TOWN OF BAY HARBOR ISLANDS
DEVELOPMENT & REVIEW COMMITTEE MEETING

1. Review and discussion of Site Plan Application by 1125 97TH Bay Harbor Condo 2618 LLC, to construct a 9-unit Multi-Family Development to be located at 1125 97 Street. Enclosed are the Site Plans and the Staff Report prepared by Town Planner Michael Miller.

**TOWN OF BAY HARBOR ISLANDS
COMMUNITY DEVELOPMENT
MEMORANDUM**

Subject: Site Development Plan Application – Formal Submittal
1125 97th Street - Multi-Family Residential Complex (9 DU)
Bay Harbor Islands Acct. No. SPR23-000028
MMPA Acct. No. 01-0702-1169

G004

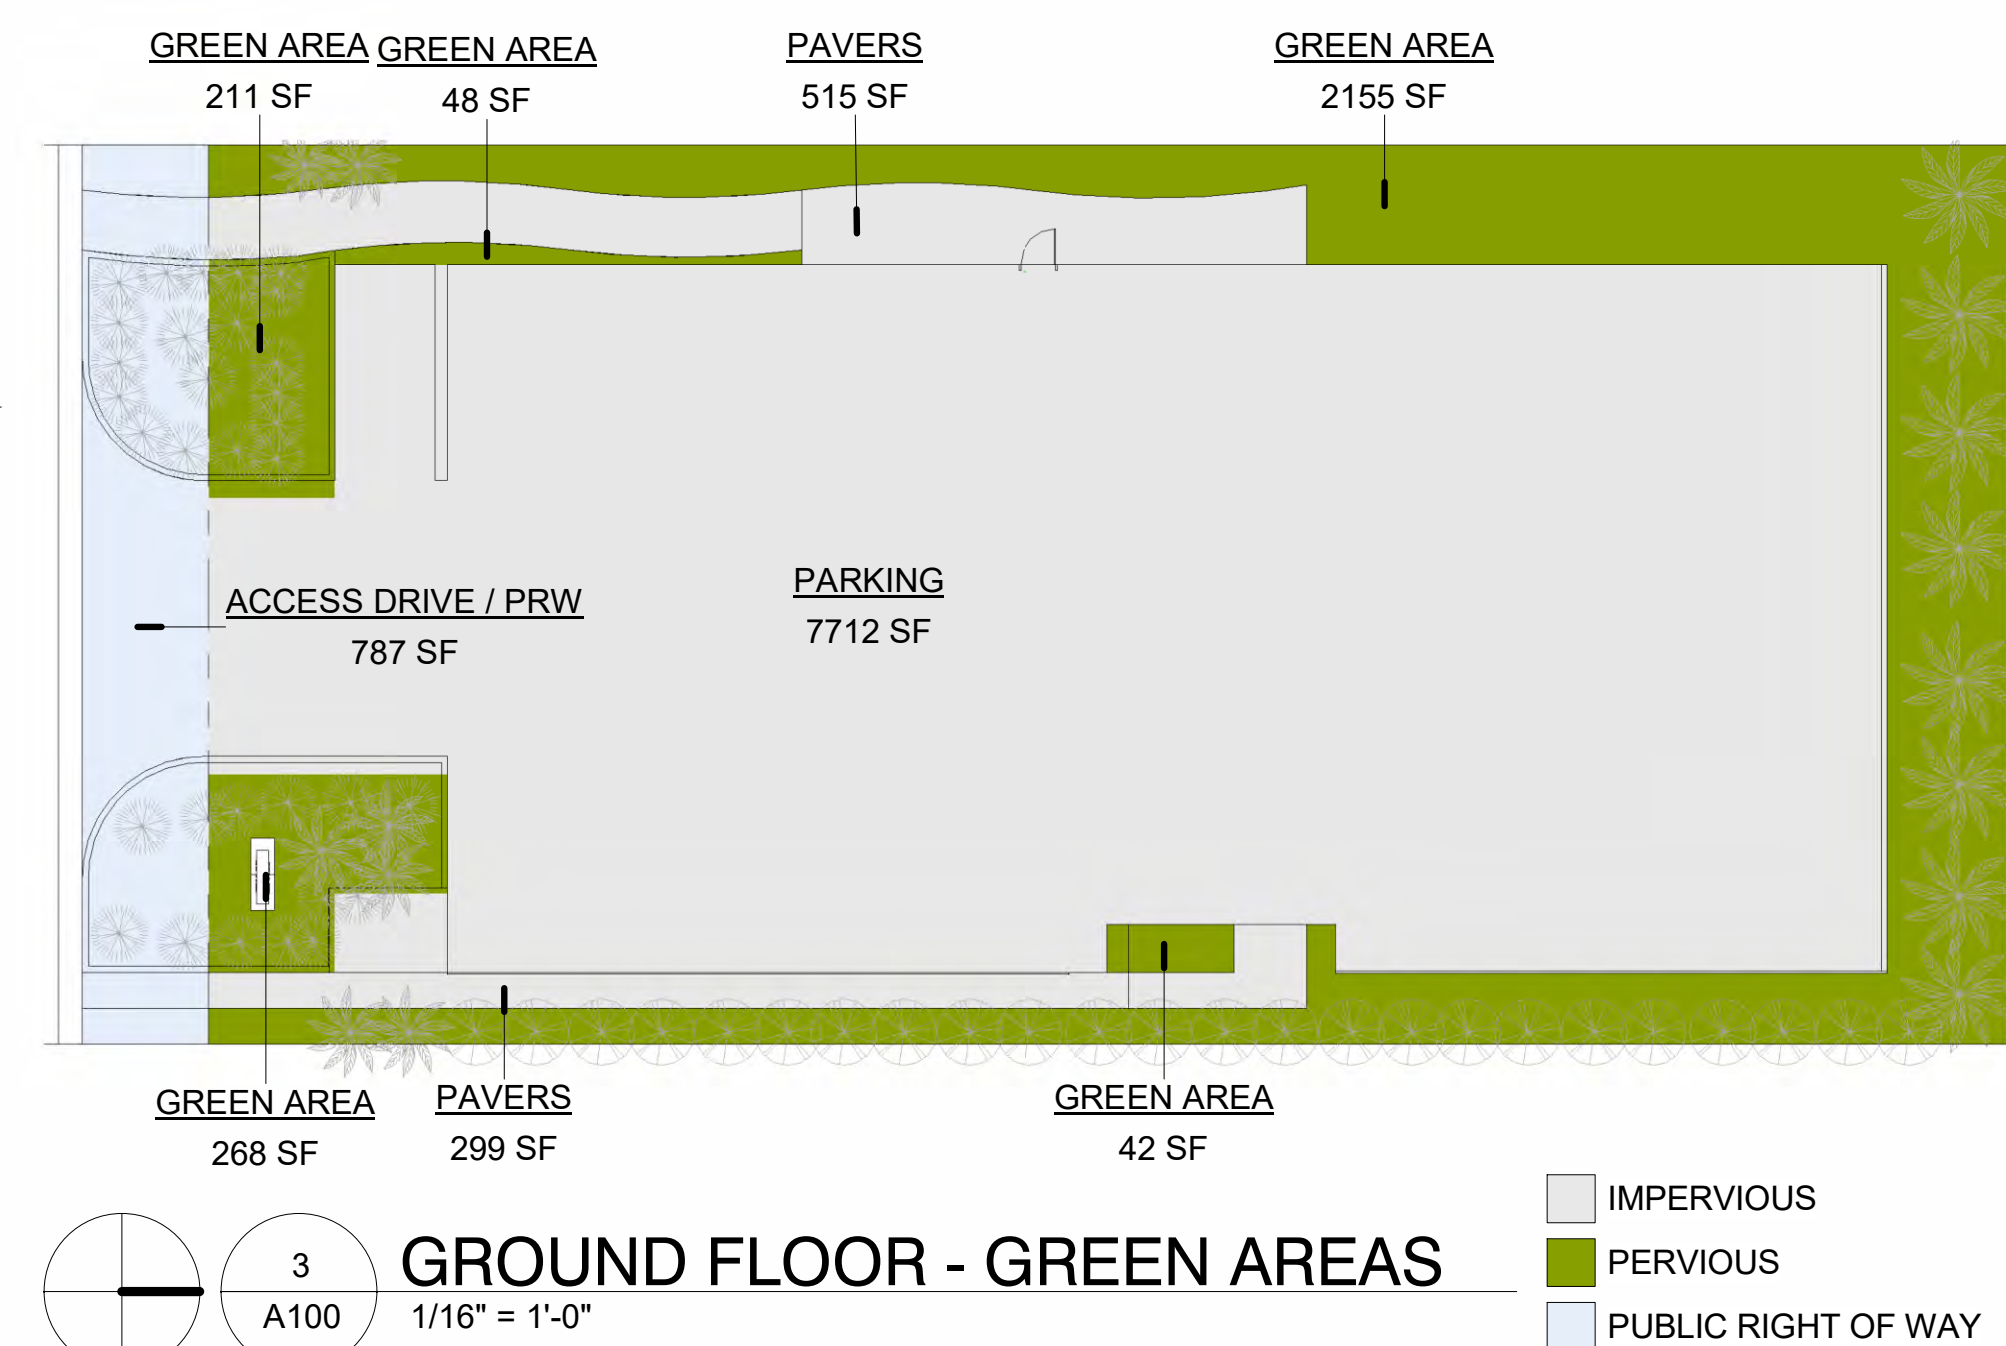
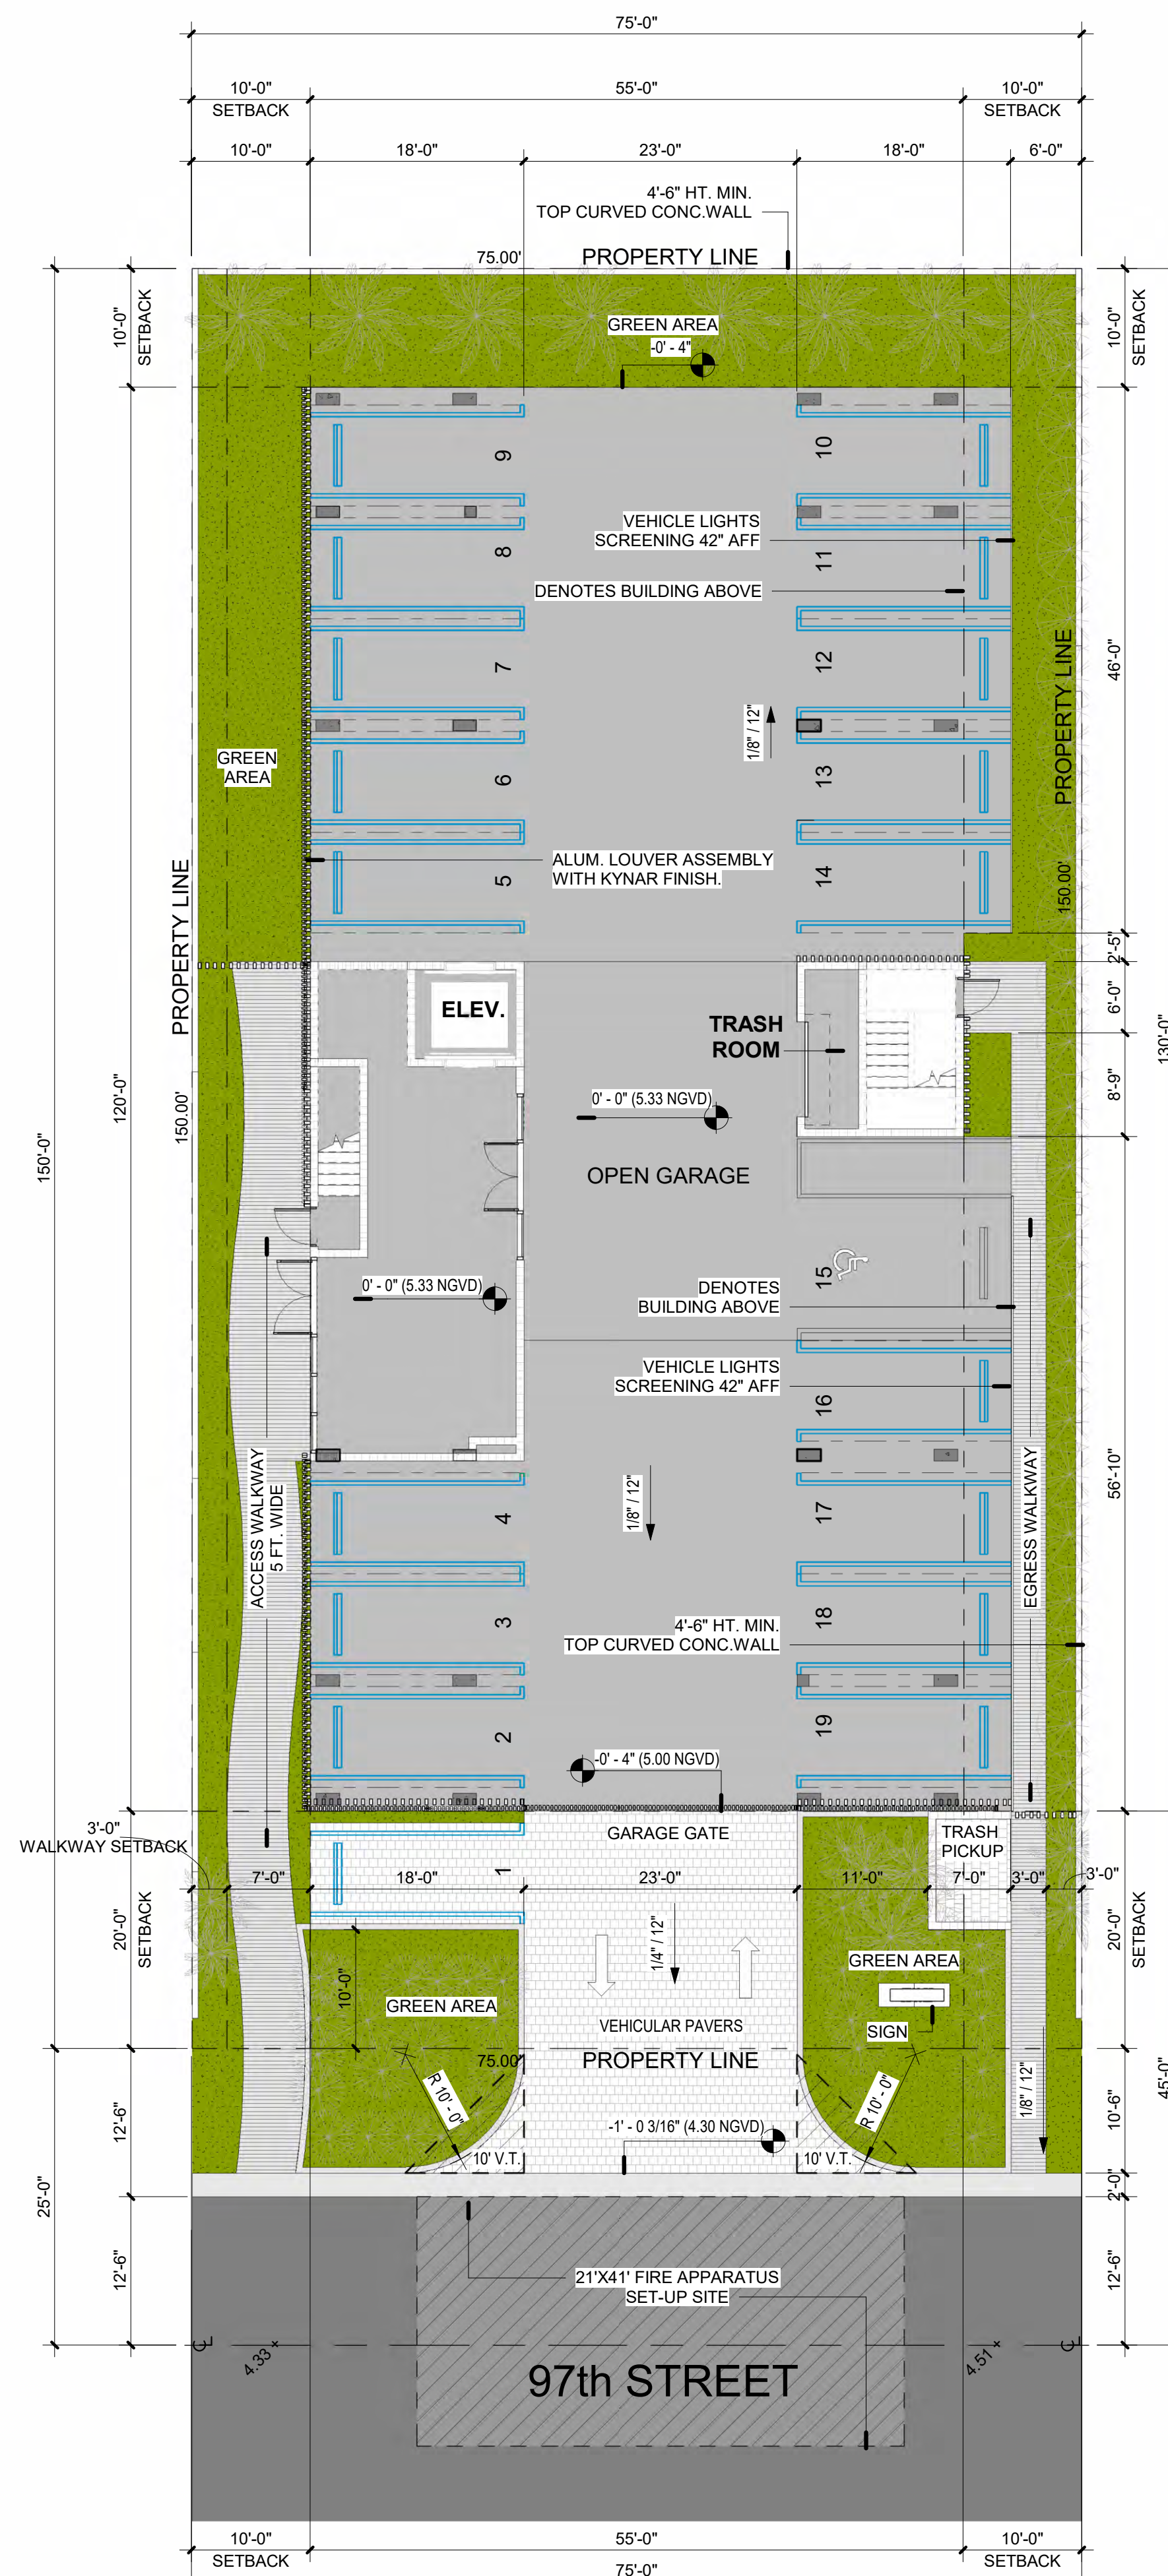
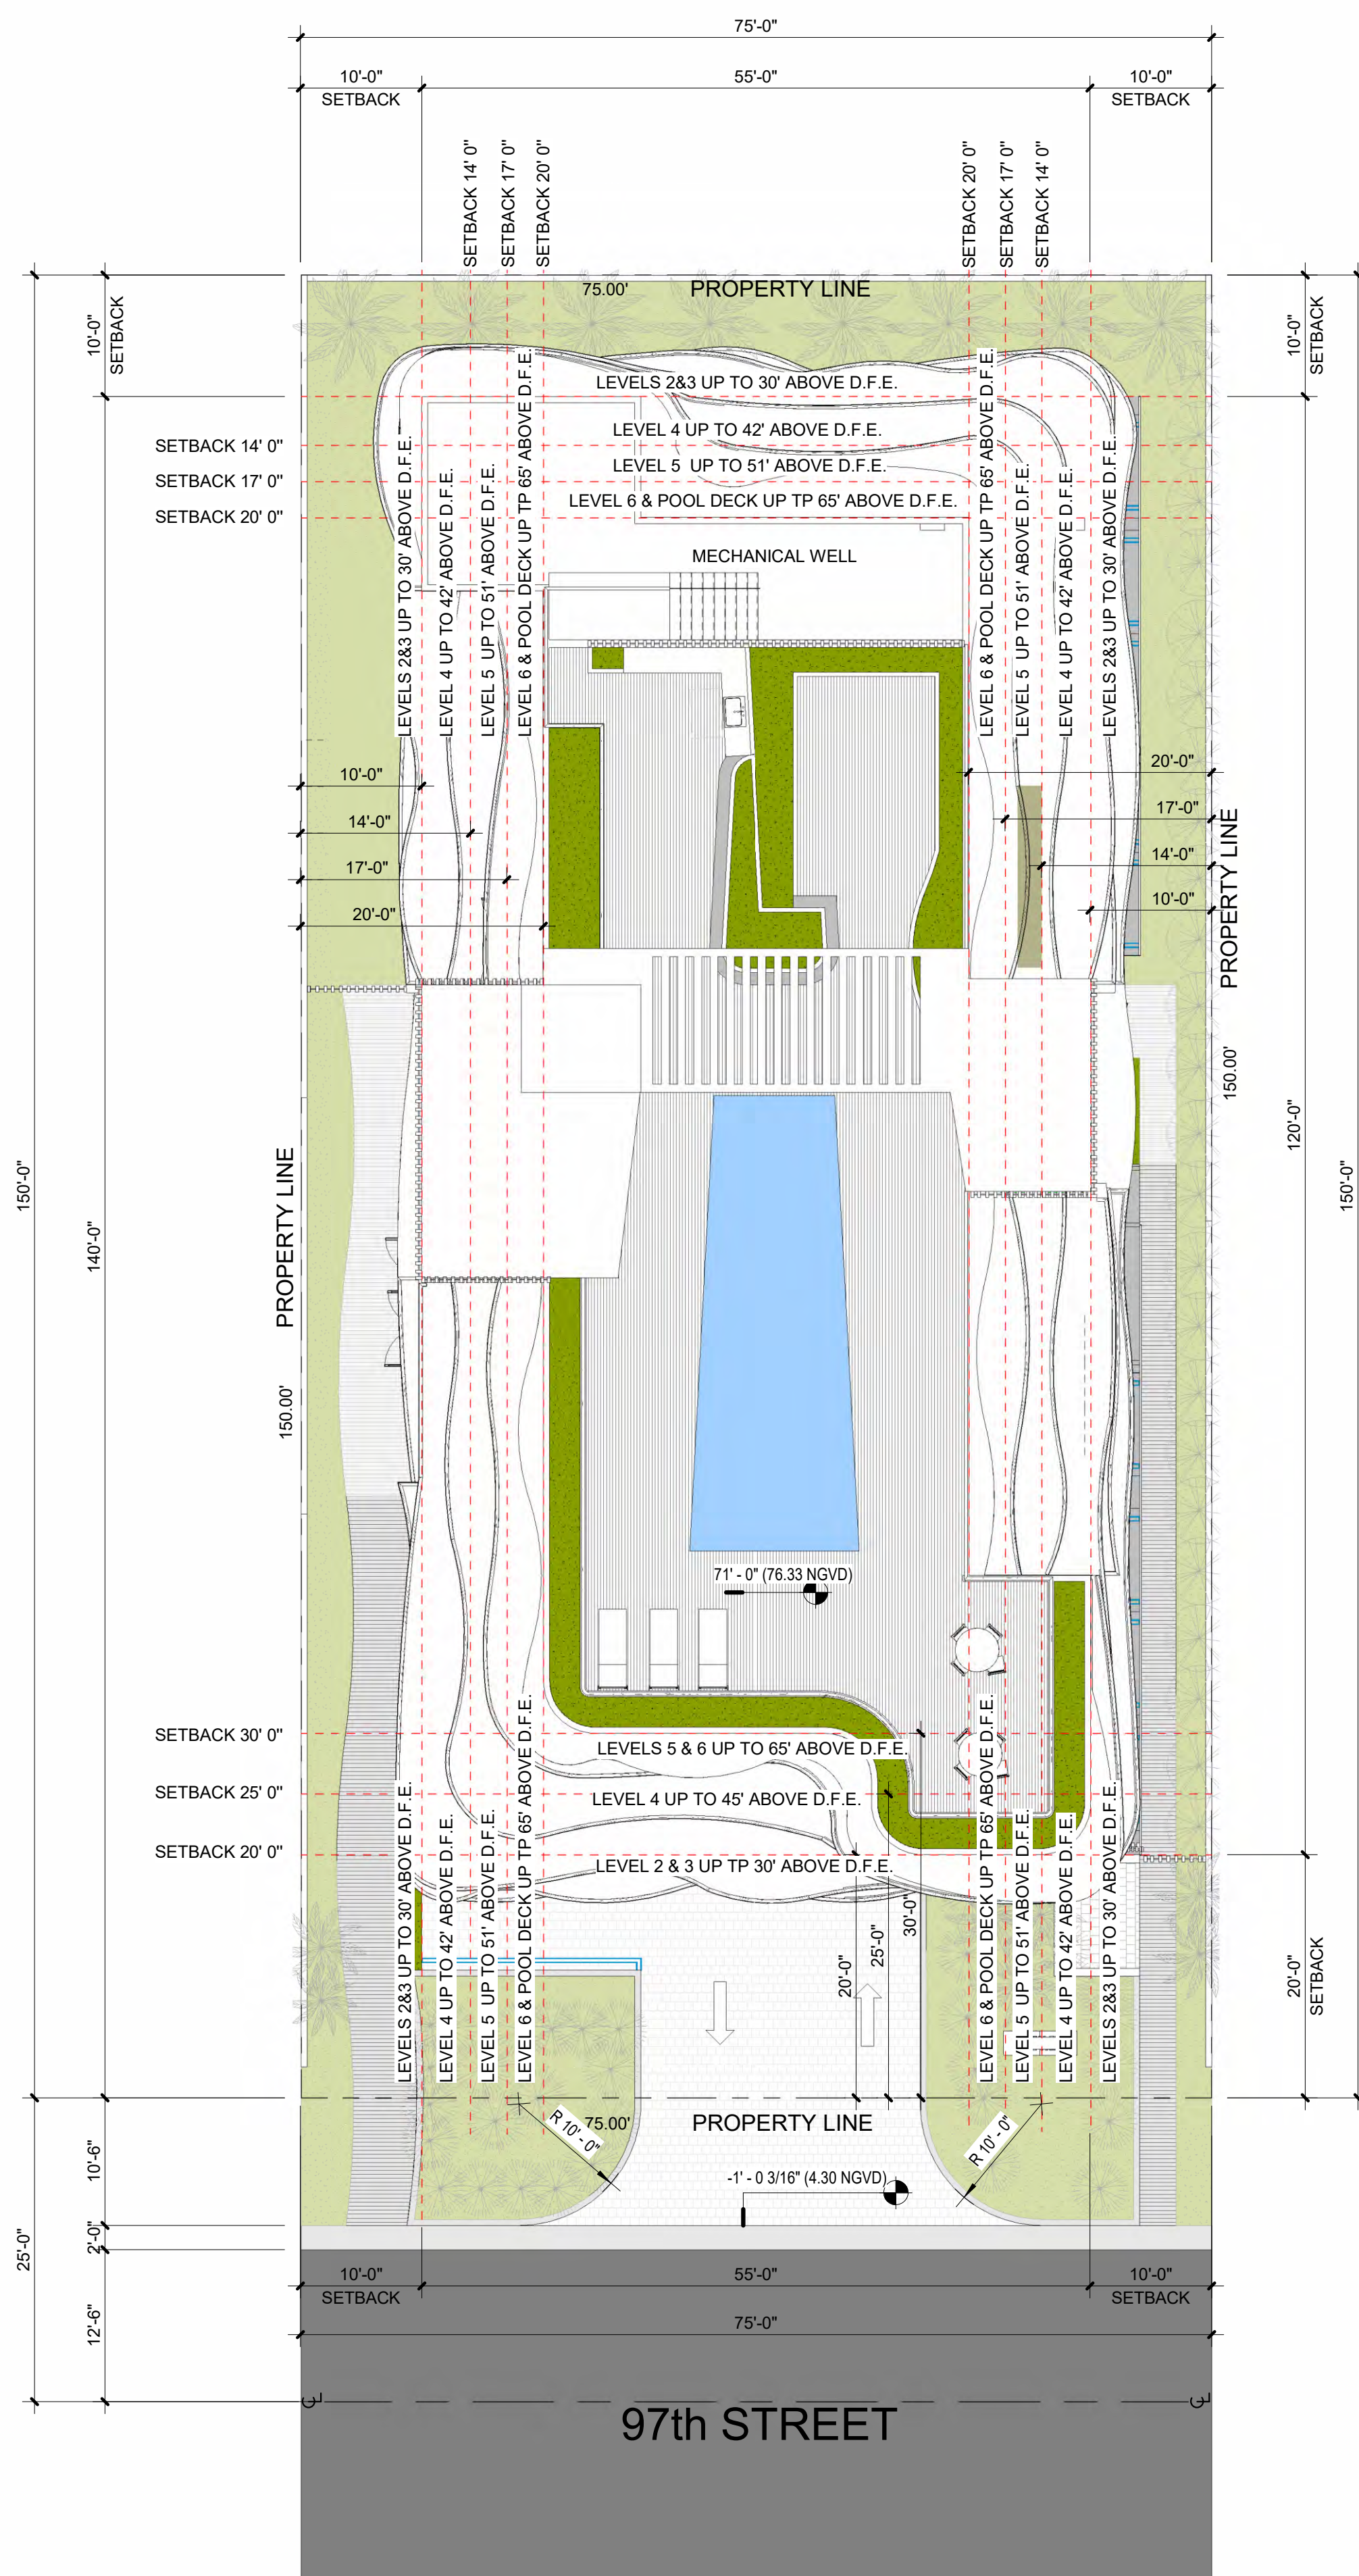
- 9) For the rooftop design a minimum of 15% of the roof area "used for recreation" must be landscaped. Sheet G004 Roof Deck detail lists the landscape area as 3,335 square feet. However, Sheet G003 Landscape Area at Roof LVL lists the area as 3,780 square feet. Please review and revise as required,
